ADA Compliance Program

Clark County Facilities Survey - Follow-up Survey - Salmon Creek Park and Ball Field

Date of Survey: October 3, 2006
Conducted by: Clark County Citizen ADA Advisory Board

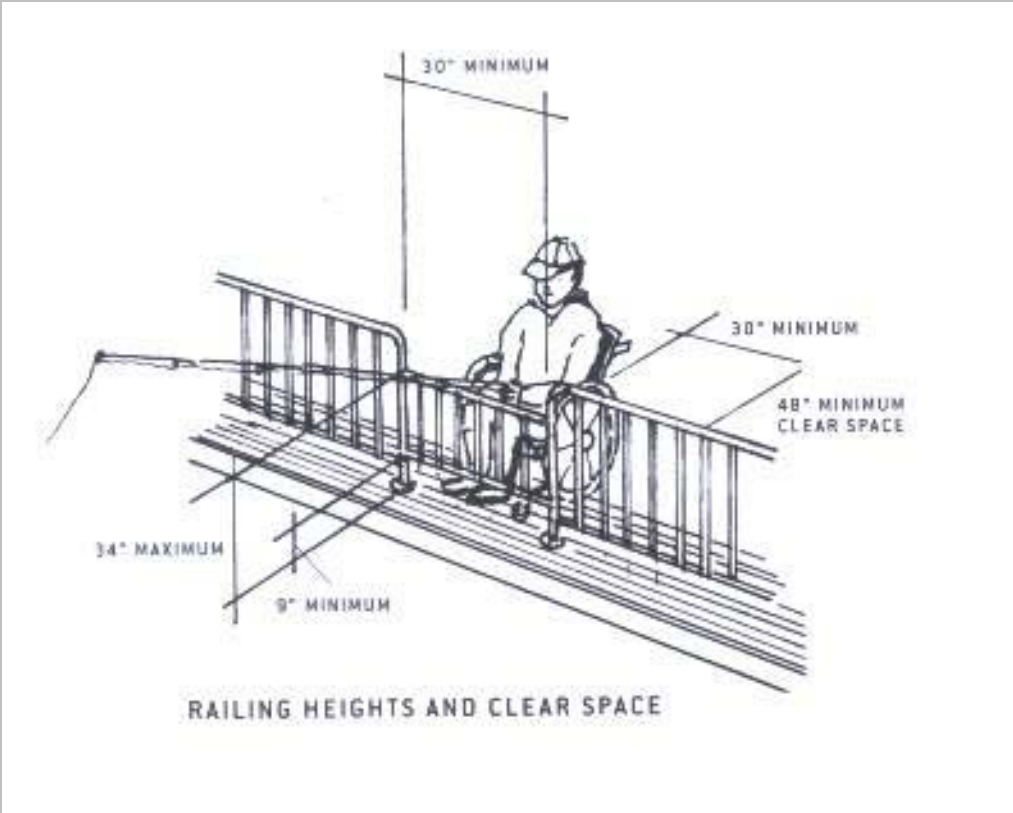
Location: Picnic Tables
 Item: Stability and Surface
 Requirements: ANSI 302.1 – General
 Floor surfaces shall be stable, firm and slip resistant.
 It is recommended that the concrete pads be extended on the ends of the picnic tables where wheelchair users can access the tables. As noted in the photograph below and to the left, the

surface where wheelchairs access the tables is uneven and extends into the grass.

Fig. 305.3
Size of Clear Floor Space

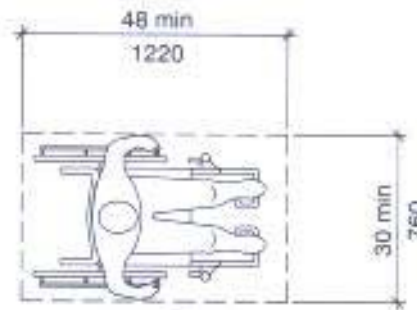
Note: The width of the three urinal stalls shown in the photo to the left are, from left to right: 30"; 23" and 20". Per ANSI Section 305.3 - Size, the minimum width must be 30 inches. However, the urinal on the left side of the photo which has a 30 inch opening is not centered within this space. This makes a forward approach in a wheelchair almost impossible. Possible solution would be to remove the far right urinal and replace it with the lower level urinal. The partitions could be repositioned to permit centered space.

Fig. 307.2
Limits of Protruding Objects

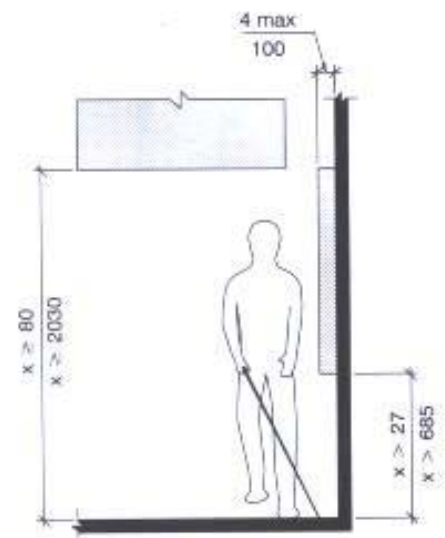
Item: Drinking Fountain – Ball Field Restroom - Protrusion Limits

ANSI 307.2 Protrusion Limits. Objects with leading edges more than 27 inches and not more than 80 inches above the floor shall protrude 4 inches maximum horizontally into the circulation path. The drinking fountain shown protrudes 18.5 inches and the height shown is 32.75 inches.

The fountain should be recessed into an alcove or protected with warning barriers.

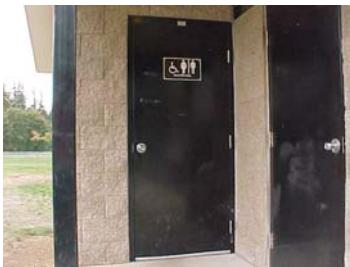
Item: Signage Location

Note: Signs need to be moved as indicated per code.
